FLOODPLAIN RESILIENCE PLAN

Planning and Sustainability Commission
Work Session

November 22, 2022

Decision Table 1: Staff Proposed Amendments to the Proposed Draft

A-1, S Reach River Environmental Modification

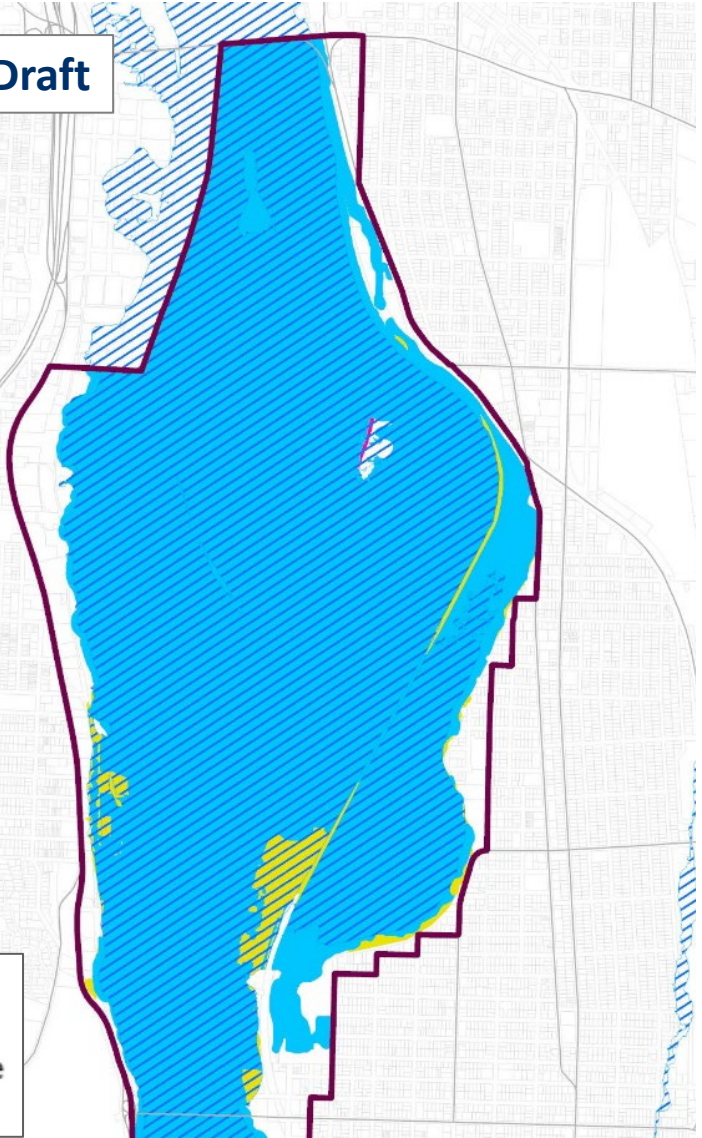
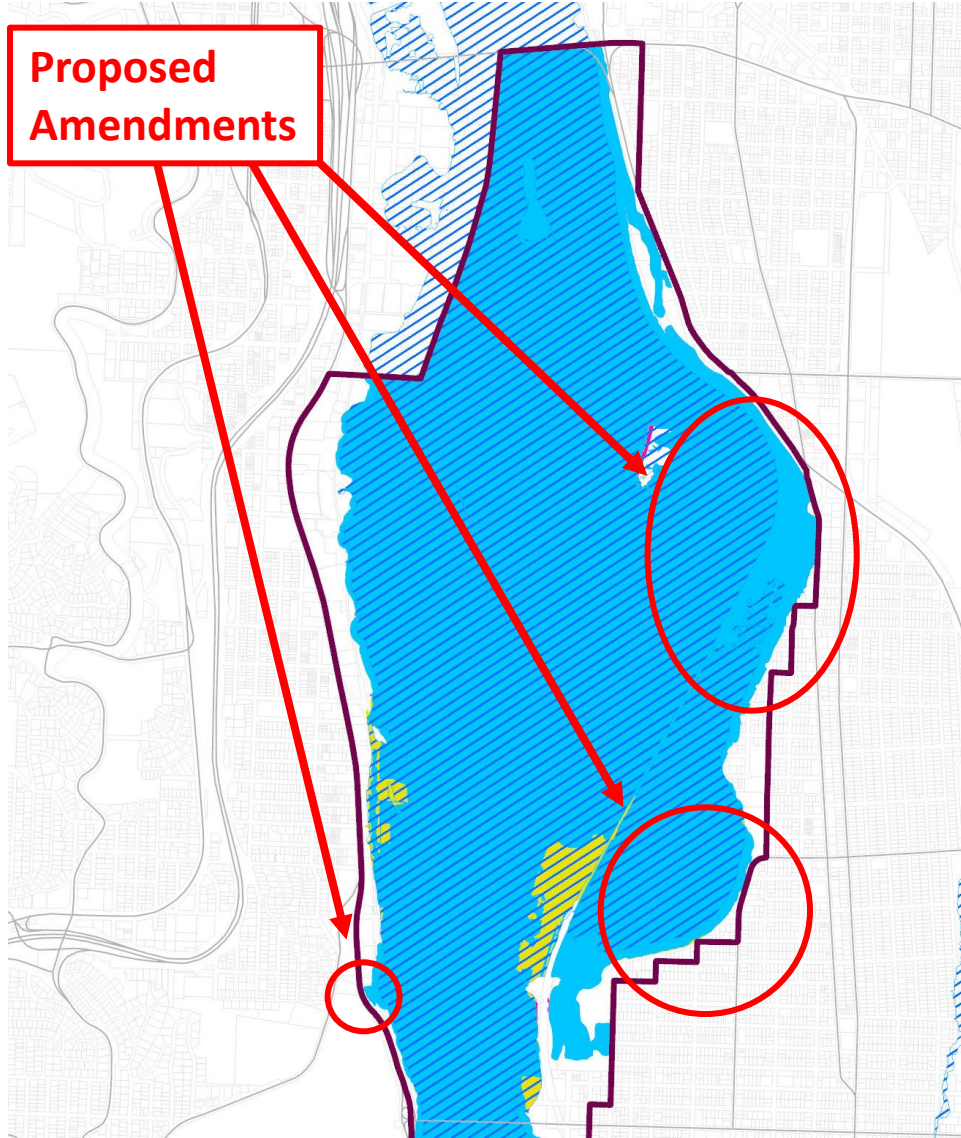
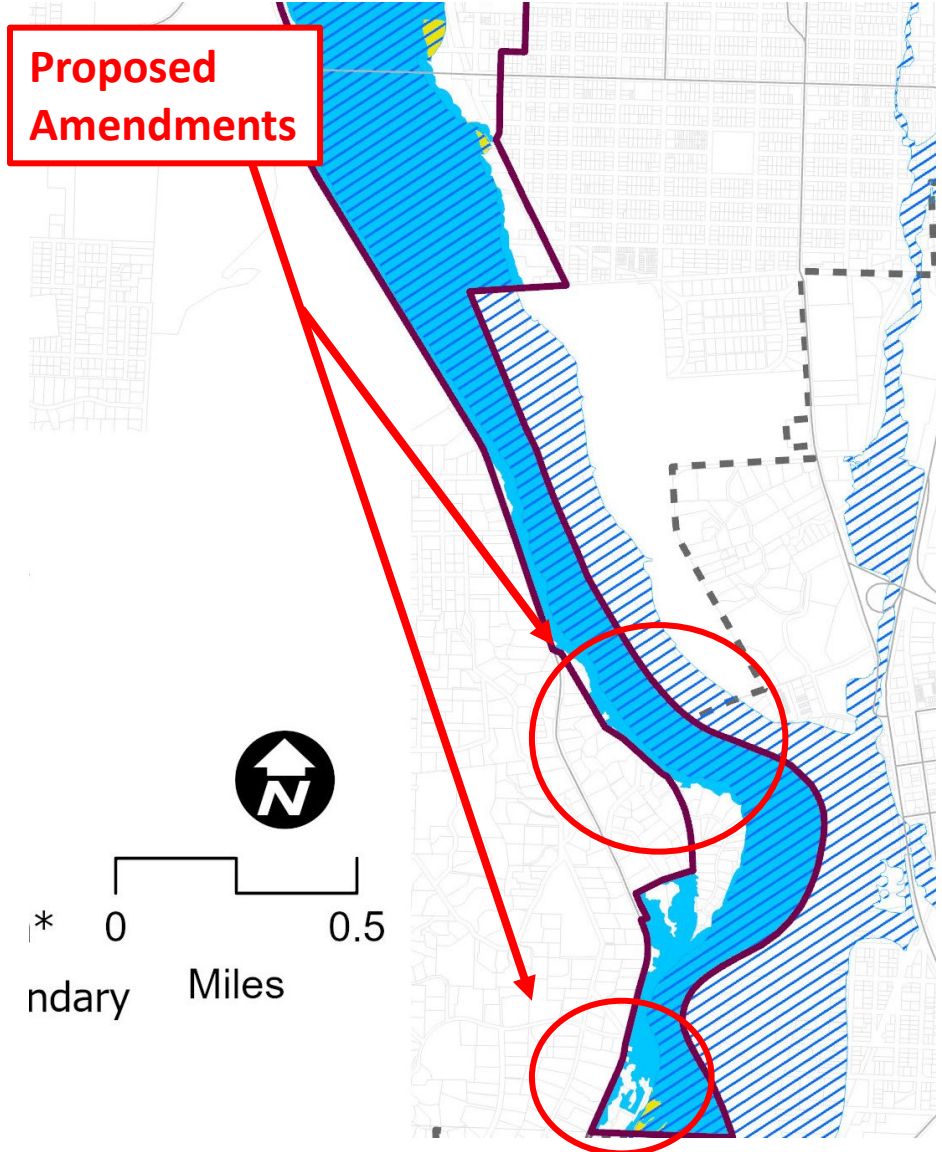
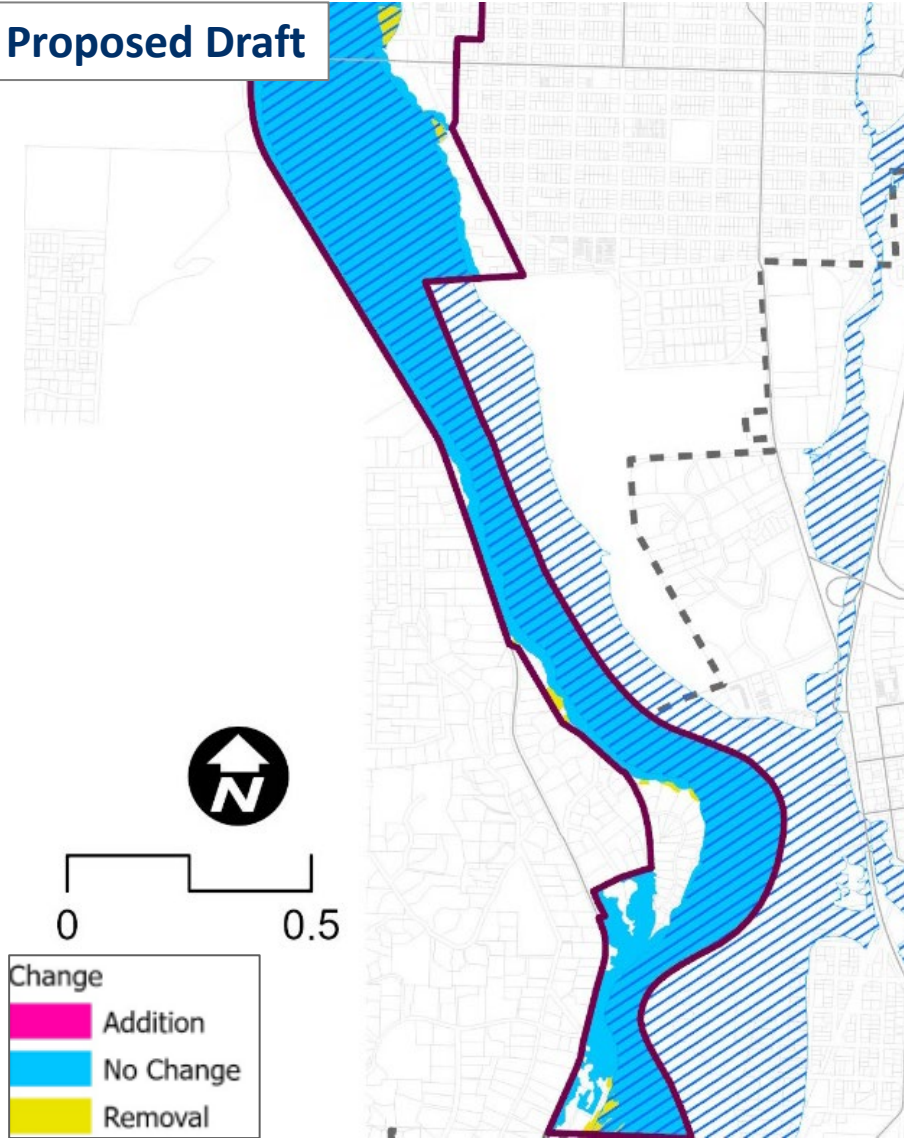
Ref #	Comment	Commenter(s)	Topic	Comment or Requested Amendment	Staff recommendation	Staff rationale	Discuss?	PSC decision
MAP AMENDMENTS								
<i>Amendment to Map 6, Proposed changes to the River Environmental Overlay Zone in the Willamette River South Reach</i>								
A-1	N/A	BPS Staff	Proposed South Reach River Environmental overlay zone	Modify the extent of the proposed River Environmental to apply it to the river setback, land within 100 feet of the top of bank, and all high- and medium-ranked riparian resources.	Replace Map 6, Proposed changes to the River Environmental Overlay Zone in the Willamette River South Reach, on page 52 of the Proposed Draft with the replacement Map 6 shown in the collection of maps in Decision Table A - Attachment 1.	The proposed River Environmental overlay in the Proposed Draft inadvertently removed some medium-ranked riparian resources that were not in the combined flood hazard area.	<input type="checkbox"/>	<input type="checkbox"/> Support staff rec. <input type="checkbox"/> Other

Proposed Amendment A-1: Replacement for Map 6 in the document

Proposed Removal of River 'e' Overlay

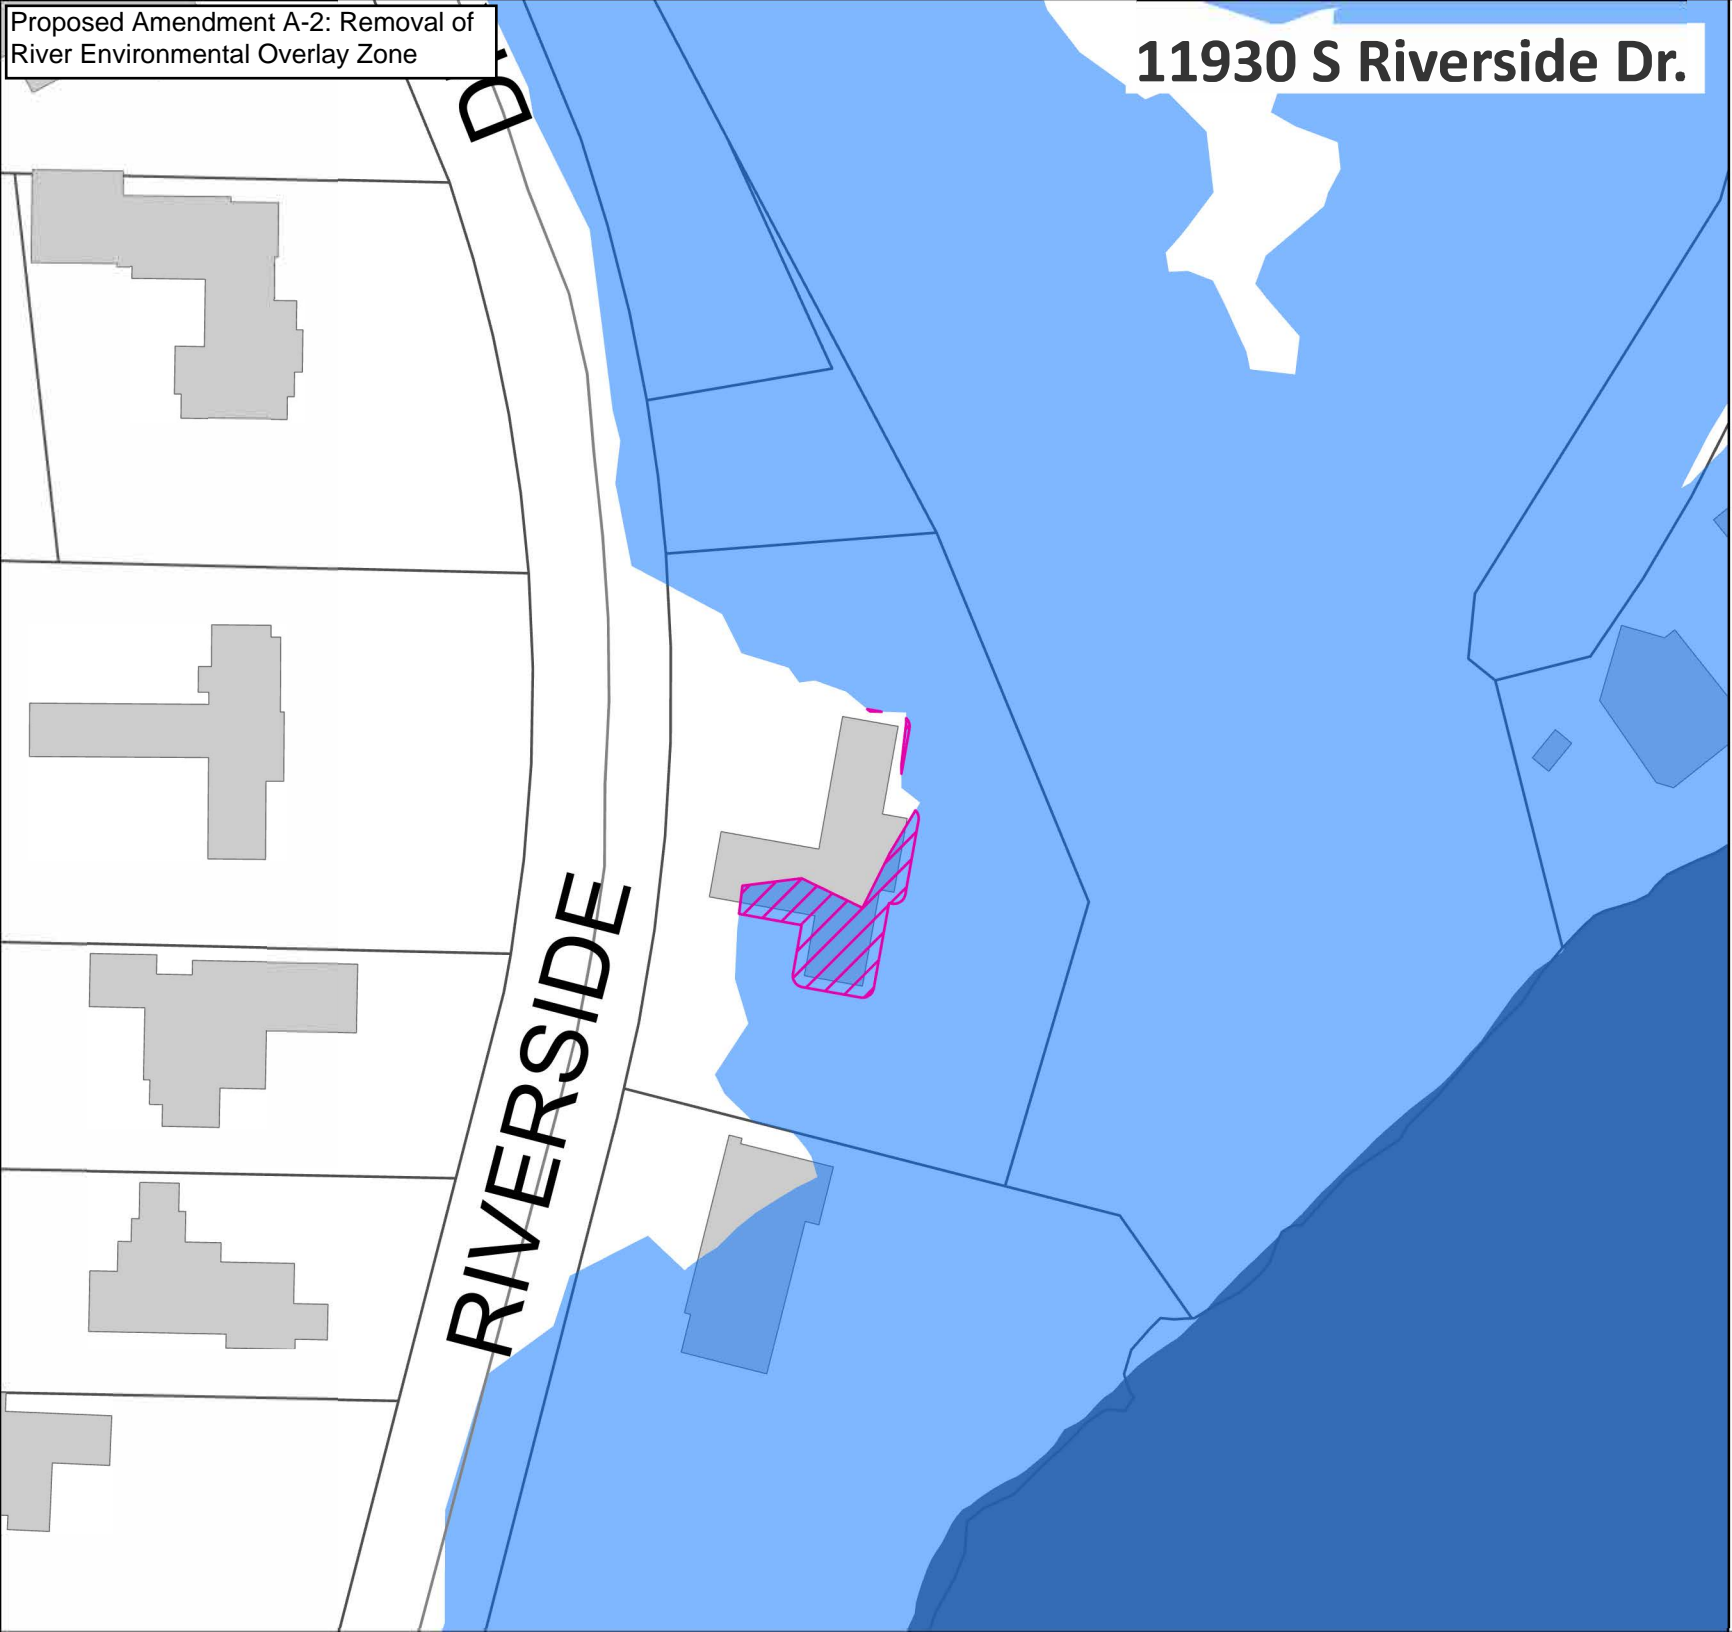
<i>Property-specific Overlay Zone Amendments</i>								
A-2	332046	Sudha Bajpai	Modification of the River Environmental overlay on 11930 S Riverside Drive	Remove the River Environmental overlay zone where it is applied to the house at 11930 S Riverside Drive and remove an additional area of at least 25 feet around the house.	Remove the River Environmental overlay zone where it is applied to the house, as shown in the collection of maps in Decision Table A - Attachment 1.	Removal of the River Environmental overlay zone from the house is consistent with the methodology utilized in the River Plan/South Reach. Removal of the River Environmental overlay zone from the area within 25 feet is not consistent with the methodology. The site is characterized by Special Habitat Area and medium-ranked tree canopy that is part of contiguous canopy that extends to the Willamette riverbank.	<input type="checkbox"/>	<input type="checkbox"/> Support staff rec. <input type="checkbox"/> Other

Figure 510-2

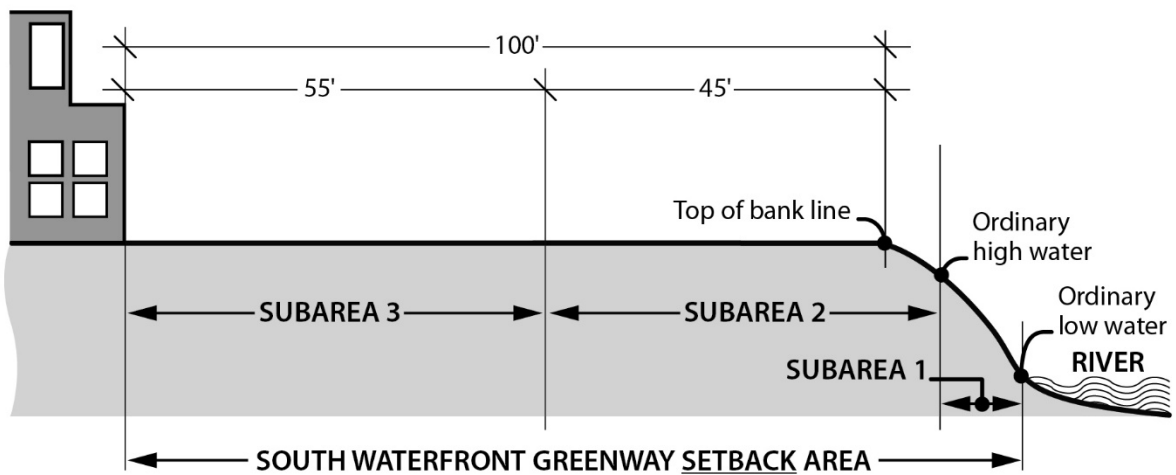
<i>Technical Amendments & Clarifications</i>								
A-11	332079	BDS Staff	Update Figure 510-2 in the South Waterfront Subdistrict (33.510.253.)	The text in Figure 510-2 should be updated throughout to include “South Waterfront Greenway <u>Setback</u> Area” throughout.	<p>Update Figure 510-2 to incorporate “setback” into the figure’s text where the “Greenway Area” is identified.</p> <p>For more detail, see all of the staff proposed code amendments in Decision Table A - Attachment 2.</p>	Not including “setback” was an oversight. It should be included in Figure 510-2.	<input type="checkbox"/>	<input type="checkbox"/> Support staff rec. <input type="checkbox"/> Other

South Waterfront Greenway Setback Area and Subareas

Greenway Setback Area = from ordinary low water to 100' from top of bank line
Subarea 1 = from ordinary low water to ordinary high water
Subarea 2 = from ordinary high water to 45' in from top of bank line
Subarea 3 = from 45' in from top of bank to 100' in from top of bank line
